RECORD OF DECISION

Operable Unit One
New Cassel/Hicksville Ground Water Contamination Superfund Site
Towns of North Hempstead, Hempstead and Oyster Bay,
Nassau County New York

United States Environmental Protection Agency
Region 2
New York, New York
September 2013

DECLARATION FOR THE RECORD OF DECISION

NCIA and OU1, Hempstead, New York
FIGURE 2.9
Date: 9/20/2013
File Path: G:\Projects\209070_IM\GIS\Graphics\CAD\GIS\111\209070_111_16_Ethane_Ratios.mxd

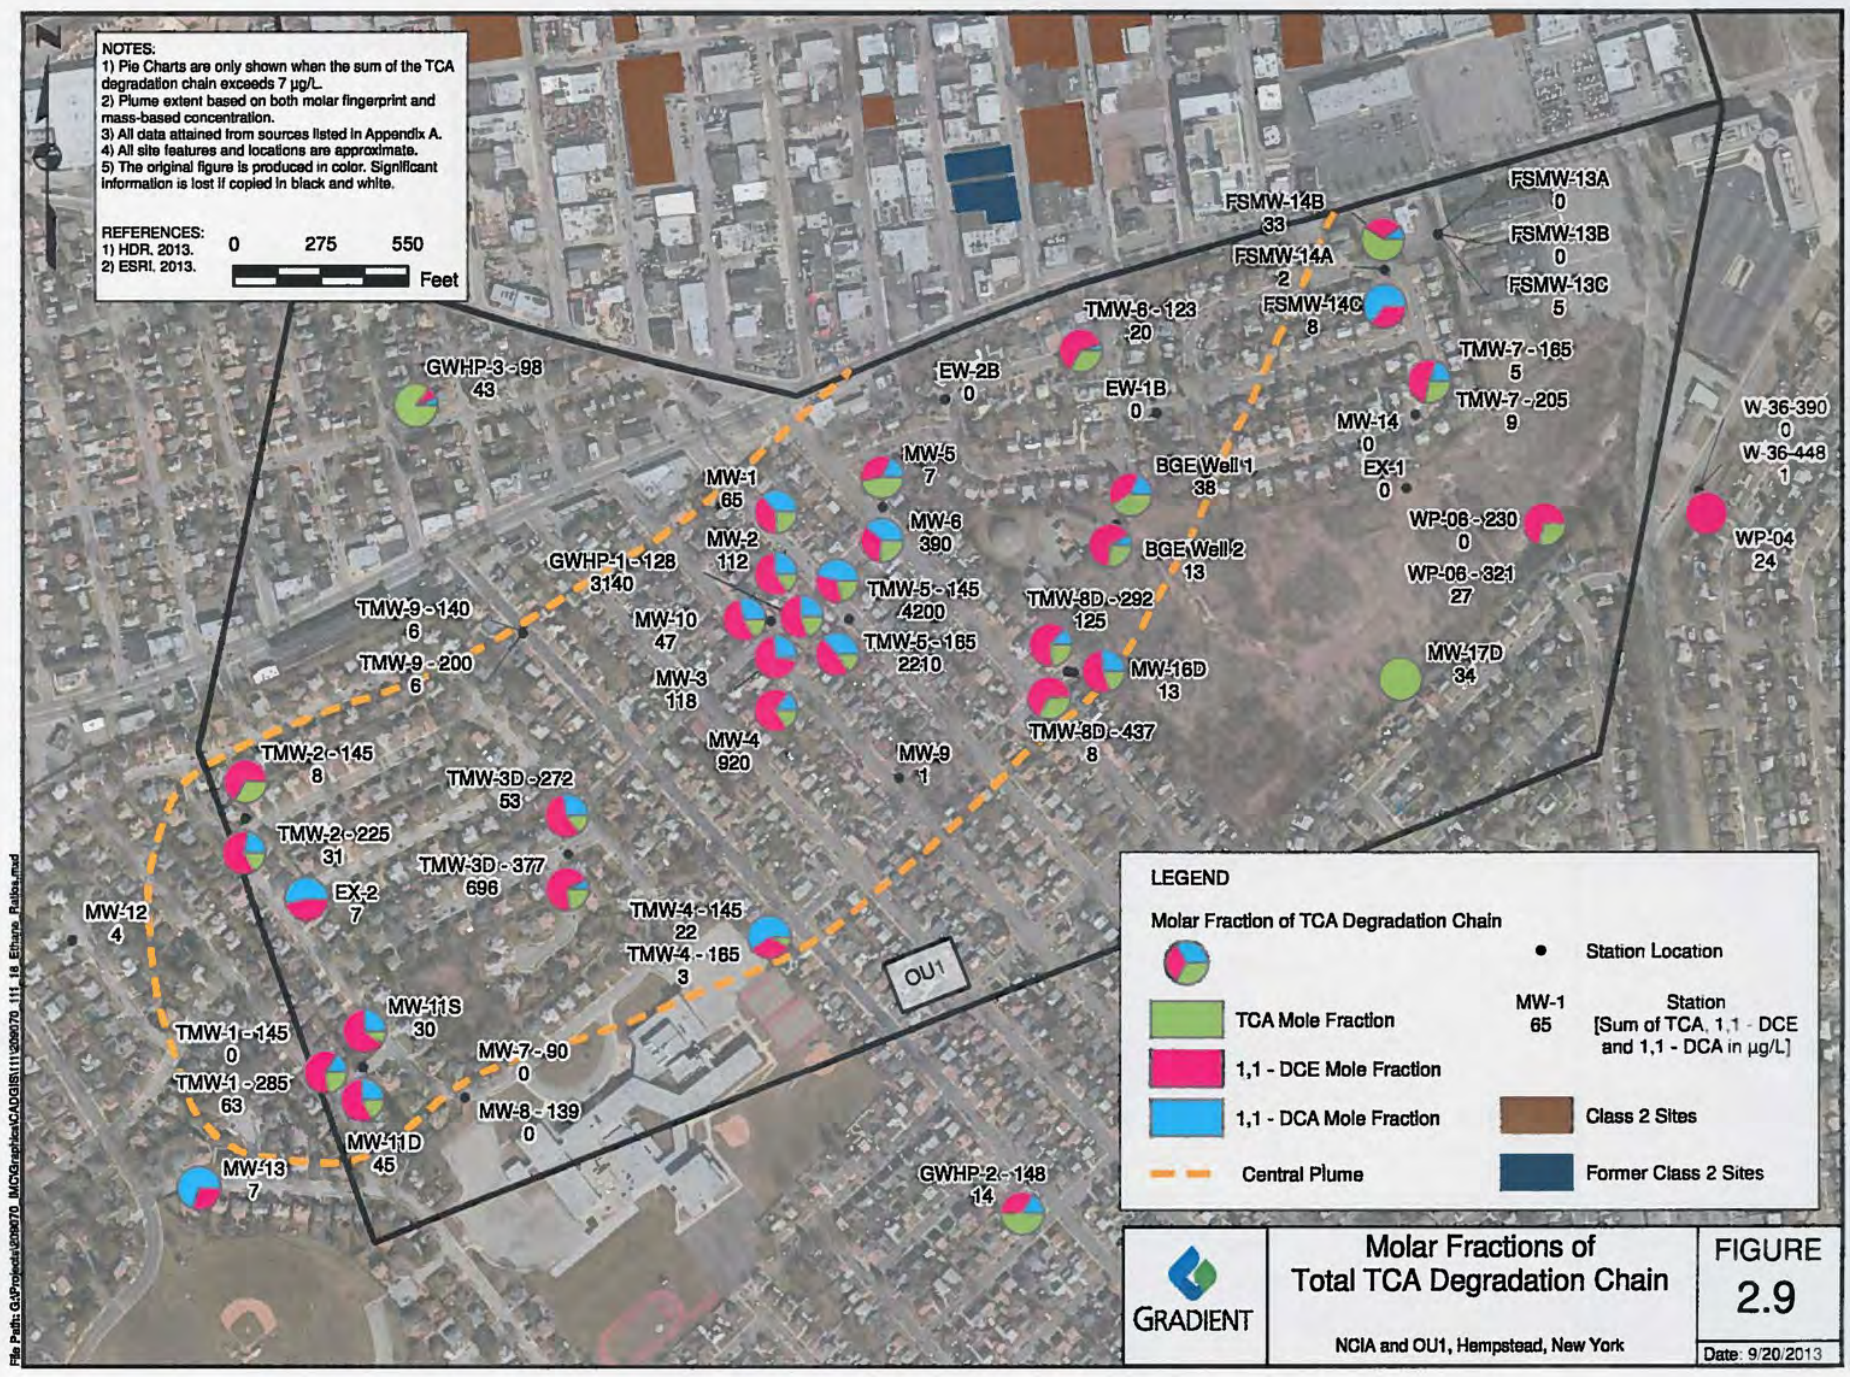
- Monitoring wells located downgradient of the NCIA Central Plume (TMW-6, MW-5/6, TMW-5, MW-1, MW-2/3/4, MW-10, GWHP-1, MW-3, MW-4, TMW-3D, and TMW-2; Figure 2.9) contain high mole fractions of TCA degradation products (1,1-DCE and 1,1-DCA). At these wells, 1,1-DCE mole fractions range up to 71% of the total TCA degradation chain; 1,1-DCA mole fractions range up to 45%. These monitoring wells delineate the Central Plume flow path through OU1.

1) ESRI, 2013.
0
300
600
Feet
GRADIENT
Molar Fractions of PCE and TCE
NCIA and OU1, Hempstead, New York
FIGURE 2.10
Date: 9/20/2013
File Path: G:\Projects\299070_IM\GIS\graphics\CAD\GIS\111\299070_111_23_PCETCEratios.mxd

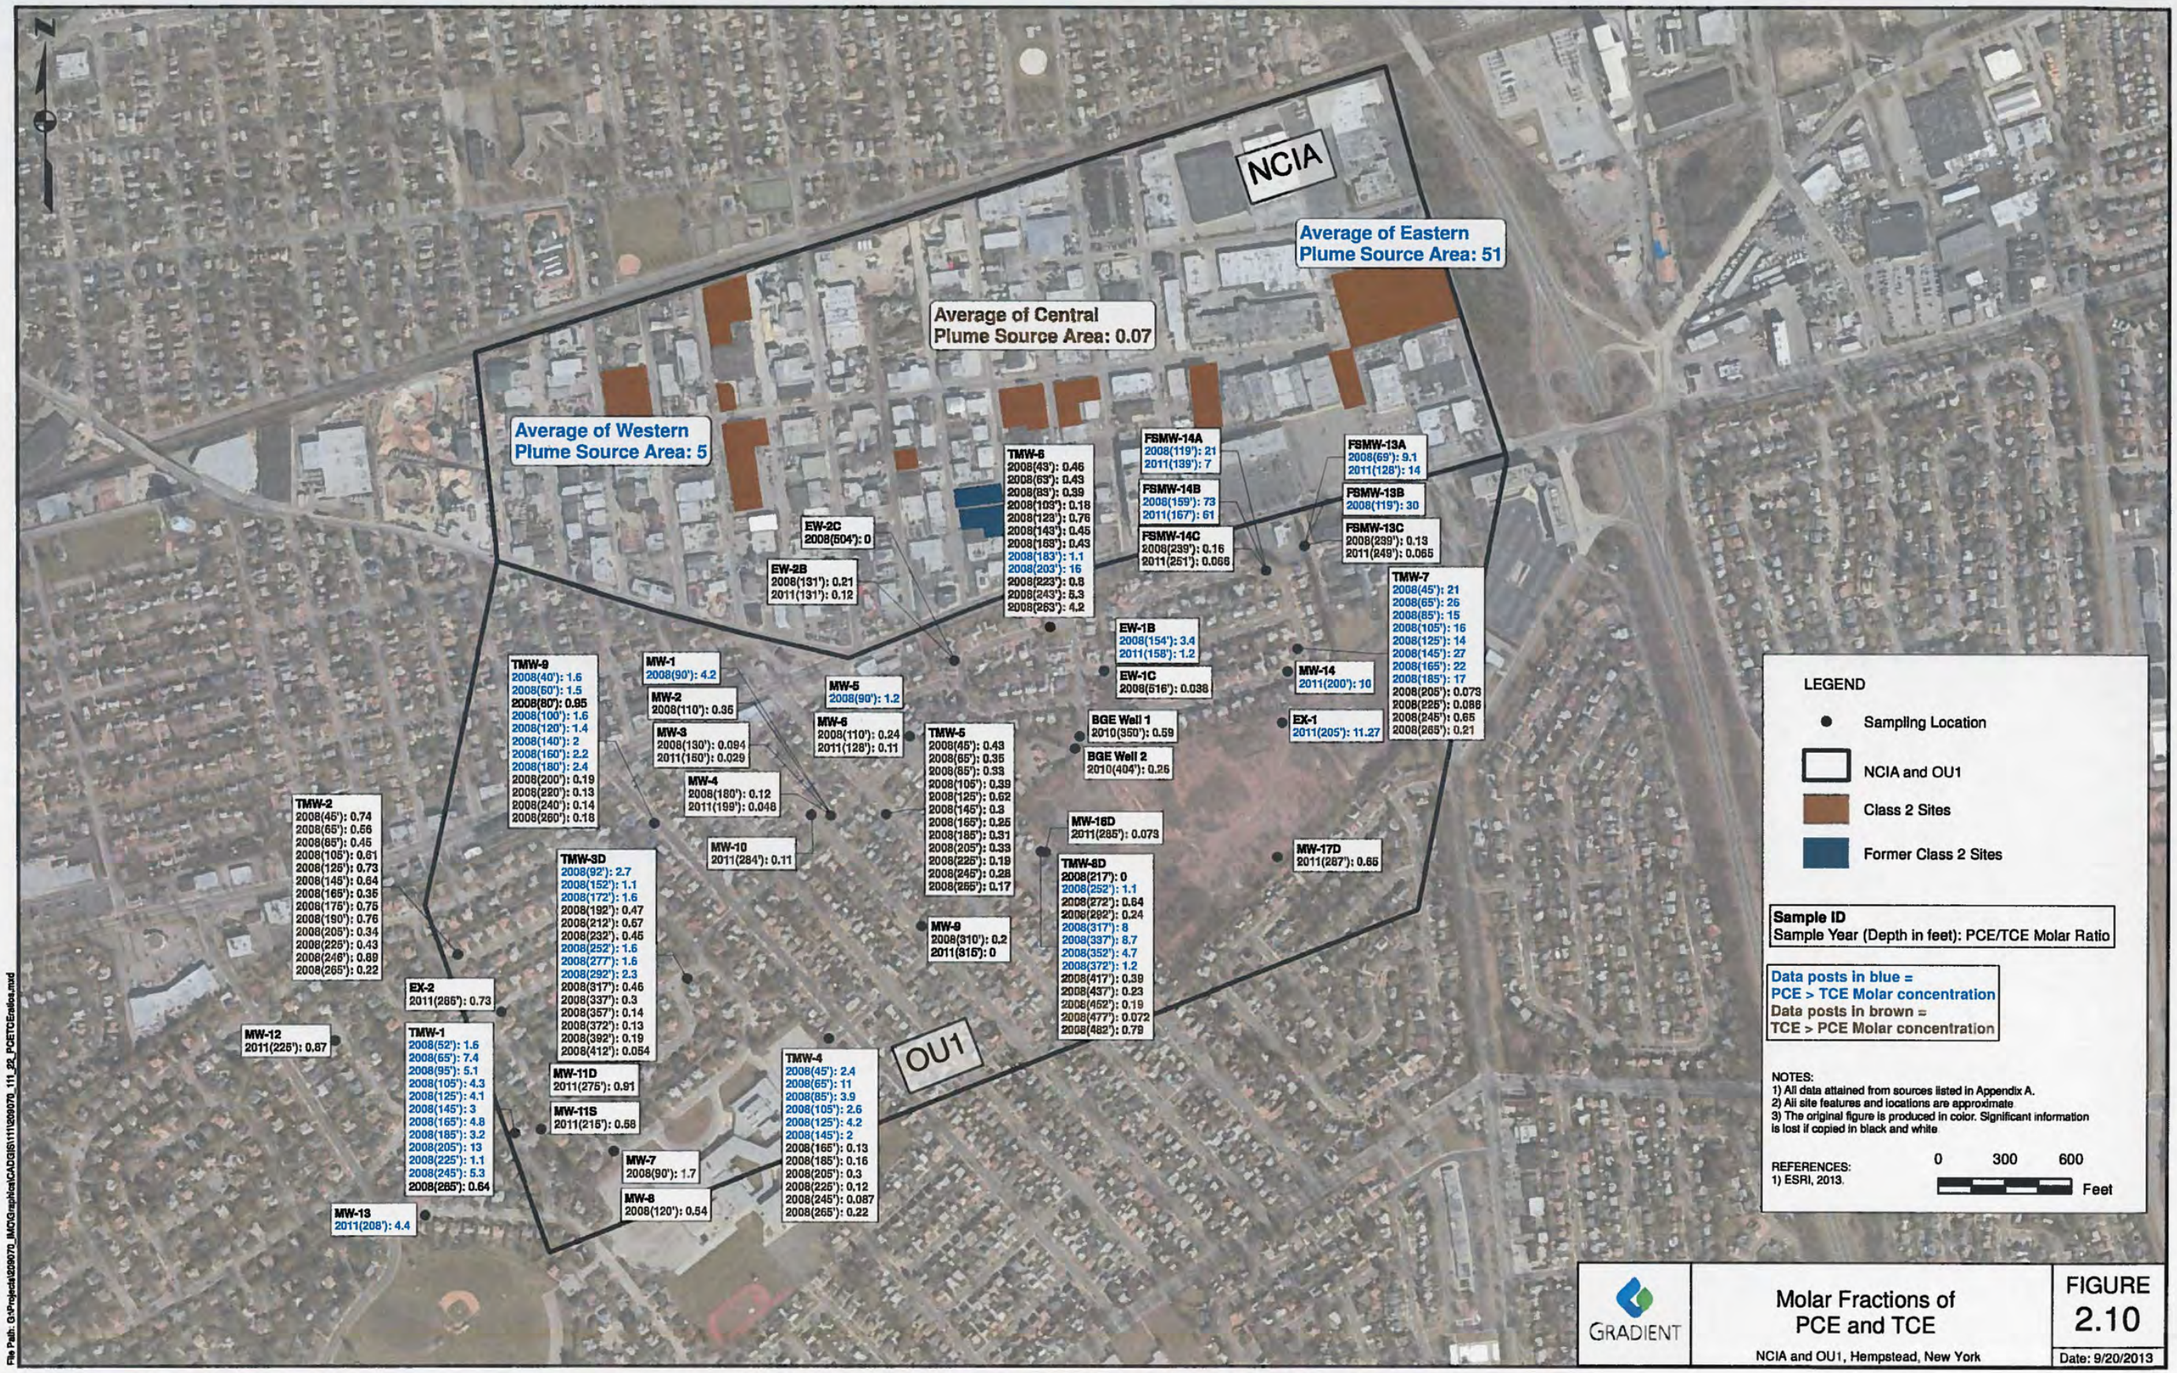
The NCIA Eastern Plume's chlorinated ethene molar signature (high PCE to TCE ratio) helps track its progression across OU1. As demonstrated on Figure 2.10, the high PCE to TCE ratios can be observed at the Frost Street Site, TMW-7, TMW-8D, and at TMW-1. At these locations, the PCE to TCE ratios are generally on the order of 10 or higher, especially in the depth intervals where high concentrations have been observed.[9] Groundwater quality data collected at these key locations also indicate that the Eastern Plume sinks very rapidly to significant depths in the vicinity of the BGEWD wells. For example, PCE concentrations were found between 292 and 372 ft-bgs at TMW-8D (D&B, 2009).[10] Due to the presence of the BGEWD wells and the stronger downward gradients present in the vicinity of the wells, the OU1 Eastern Plume plunges quickly west of TMW-7. In addition, there is a large recharge basin (Basin 51) present immediately to the south of the BGEWD well field. Groundwater elevations collected at monitoring wells located near the recharge basin (MW-15, MW-16S/D, and MW-17S/D) rose sharply (0.5 to 1 foot) on April 17, 2011, in response to a 1.38 inch precipitation event on April 16, 2011 (HDR, 2011, Figure 15).[11] This hydraulic response also indicates that the recharge basin could be further increasing the downward vertical gradient in this area (due to the groundwater mound associated with the recharge basin), thereby pushing the Eastern Plume deeper.

FIGURE 3.1

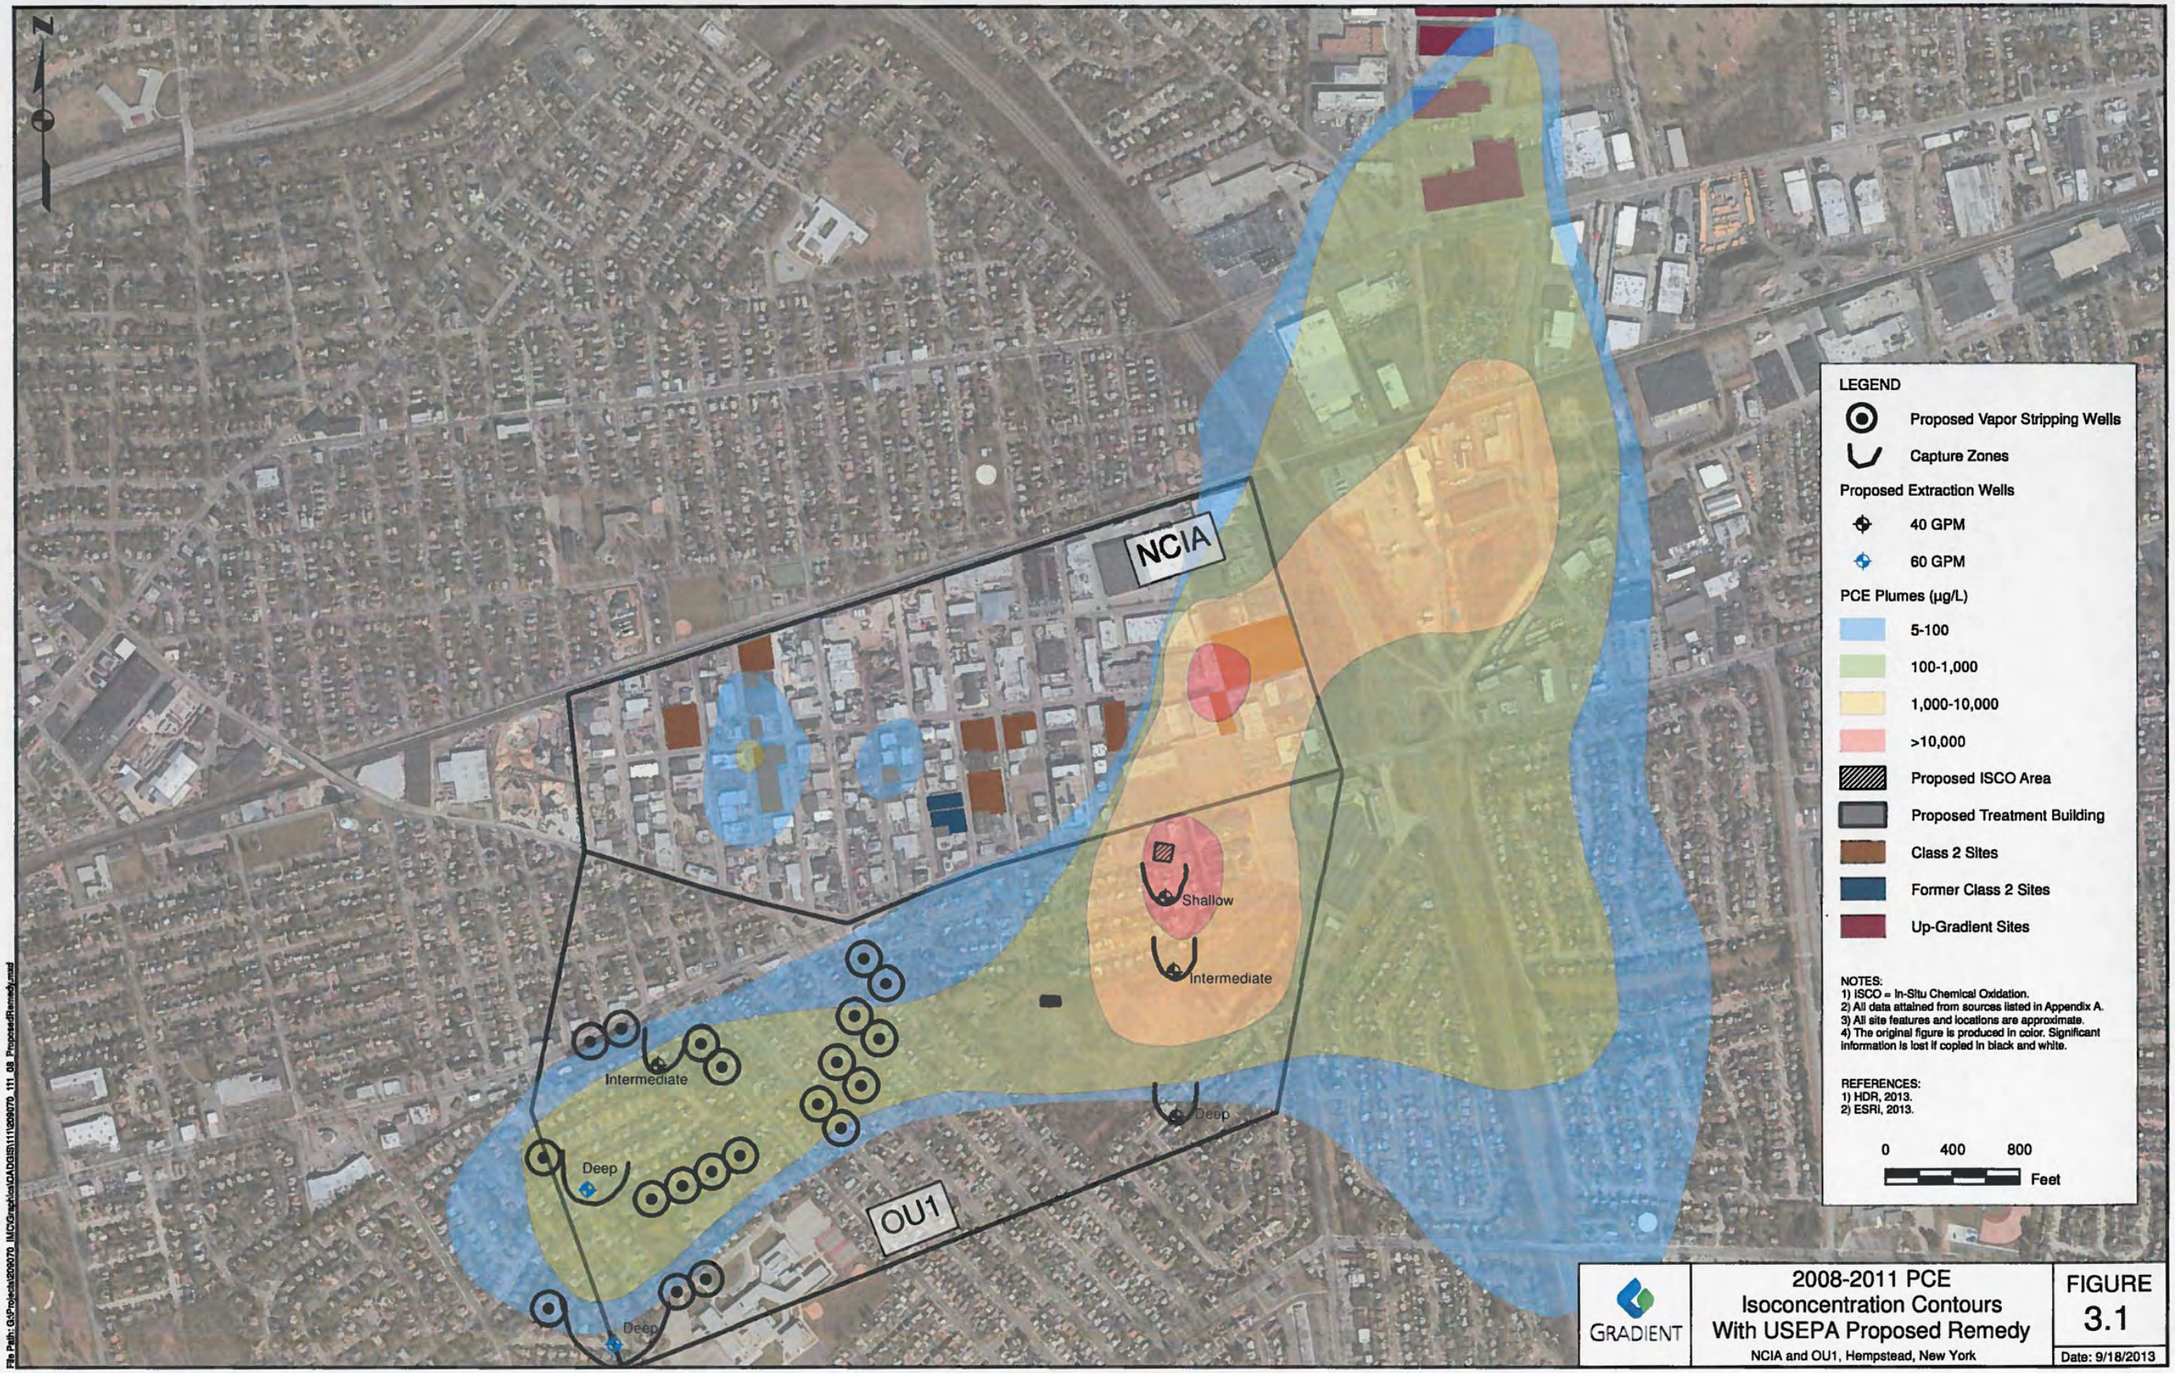
By failing to accurately characterize the groundwater flow and plume migration directions, USEPA's Proposed Plan is fundamentally flawed and will not achieve the Remedial Action Objectives (RAOs). Figures 3.1 and 3.2, which present an overlay of the proposed USEPA remedy on the current PCE and TCE plume configuration, illustrate the problems with the proposed remedy design. The remedy was designed so that both groundwater extraction wells and in-well vapor stripping wells "blanketed" the plumes; however, because USEPA's CSM relied on an incorrect chlorinated organics molar ratio analysis approach and an incorrect groundwater flow direction (Sections 2.5 and 2.3, respectively), the proposed remedial well locations are not optimally placed. For example, USEPA has placed four in-well stripping wells and an intermediate groundwater extraction well in the northern portion of the OU1 Western Plume based on its conclusion that contaminants from the western portion of the NCIA are continuing to migrate into OU1. These wells are completely unnecessary, since as demonstrated in the corrected CSM (Section 2.7), the NCIA Western Plume is not contributing to concentrations measured in the OU1 Western Plume; due to the low concentrations in the OU1 Western Plume, MNA is a more appropriate remedy for this portion of the Site (Section 3.2).

The number of active remediation wells proposed for the three USEPA-designated OU1 Plumes are not consistent with the observed contamination. The Proposed Plan locates a significant number of wells (20 in-well stripping wells and 3 groundwater extraction wells) at the downgradient edges of the plumes, but in comparison, does very little to address the head of the plume (*i.e.*, the OU1 Eastern Plume), which is contributing a significant majority (approximately 750 kgs/yr; see Section 2.7.2) of the contaminant mass to OU1 (Figures 3.1 and 3.2). As discussed in Section 2.7, a significant quantity of DNAPL is present at the Frost Street sites (NCIA Eastern Plume) and high groundwater concentrations are continuing to flow into OU1 in this area. Figure 3.1 shows that that the highest PCE (and other CVOC) concentrations are
